Sample Approval Form

Die #: 15750 (NEW DESIGN)
Description: CHAMCLAD 6” SOFFIT PANEL

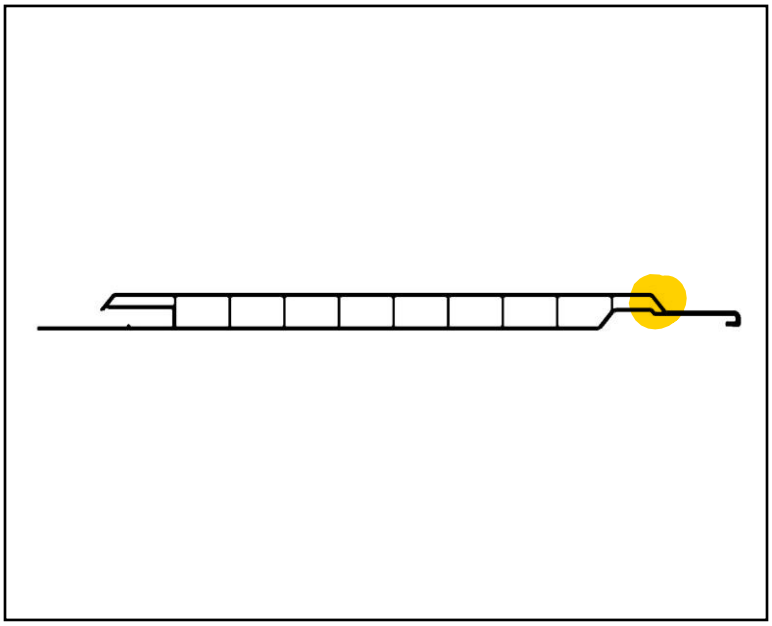
Comments: This profile is approved, but please ensure proper quality checks are in place at the area highlighted that it remains straight and the transition between the top horizontal wall and the diagonal wall coming down the "V-groove" is sharp. The samples received had a curved transition between the top horizontal and diagonal wall and was not accepted.
